Wichita-Sedgwick County Metropolitan Area Planning Department

Re: CON2002-00051: An administrative adjustment to Condition #4 of CON2002-00018.

VOICE STREAM
PARKING LOT EXPANSION
PROJECT NAME

ELECTRICAL SITE PLAN
SHEET TITLE

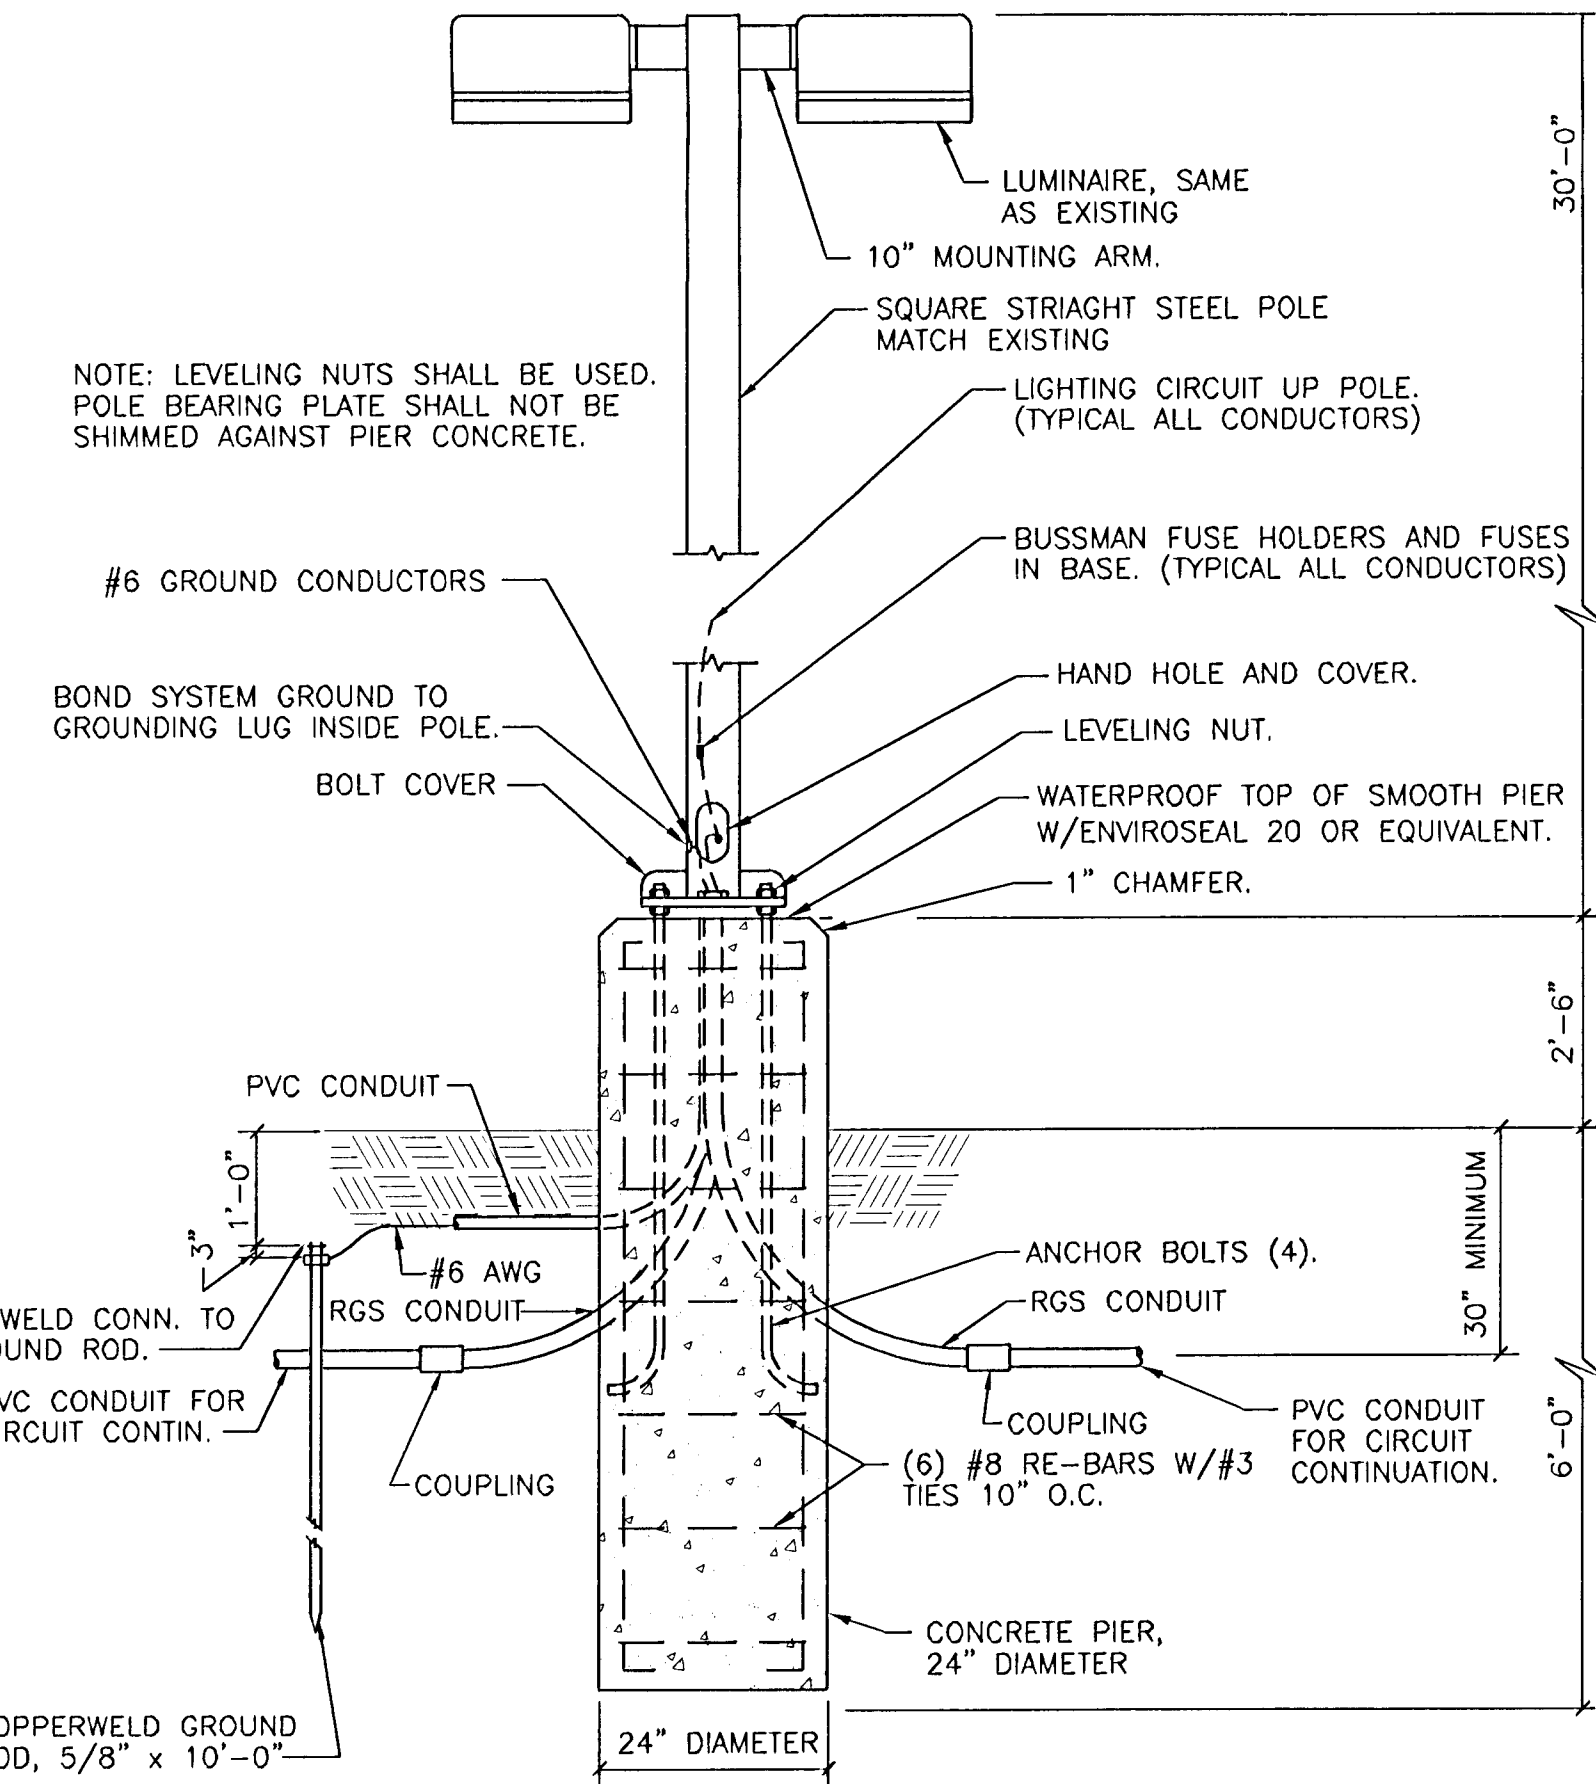
We have reviewed your request for an administrative adjustment to the site plan for CON2002-00018. You state in your application that you desire to adjust Condition #4 to increase the height of light poles and fixtures from a maximum height of 14 feet to a maximum height of 30 feet. The light poles would be placed in the center of the parking lot and be located no closer than 70 feet from the property line of residential zoning.

- 1) Impact on safety and convenience of vehicular and pedestrian circulation: The use of taller light poles and fixtures is intended to increase the safety of the parking lot for the patrons.
- 2) Impact on existing uses in surrounding areas: The taller light poles and fixtures would be located in the center of the lot by a distance of at least 70 feet to any residential property line.

This exceeds the minimum distance from a residential lot line of 60 feet for a 30-foot pole required by the Unified Zoning Code. Additionally, the adjusted landscape plan and concurrent adjustment of Condition #2 of this Conditional Use, provides for a denser landscape buffer along the north, east and west property line, which should further mitigate negative impacts on surrounding residential areas.

Our signatures below indicate that an administrative adjustment to CON2002-00018 Condition #4 to increase the height of light poles and fixtures to 30 feet on the aforementioned property is hereby granted subject to the following conditions:

- 1) Any poles and fixtures higher than 14 feet shall be at least 70 feet from any property line zoned for residential use.
- 2) Condition #2 shall be adjusted to require a landscape buffer along the screening wall on the north and east property lines to be increased to one tree every 30 feet, with at least one-half being evergreen, and an additional three evergreen trees shall be added to the northern 80 feet of the drive aisle on the western property line of the parking lot.
- 3) The lighting shall meet all other standards of Unified Zoning Code Article IV, Section IV-B.4.
- 4) The site shall be developed in general conformance with the site plan.
- 5) All conditions of approval, as modified by this adjustment, for CON2002-00018 shall be met.
- 6) Any violation of these conditions shall render the Administrative Adjustment null and void.
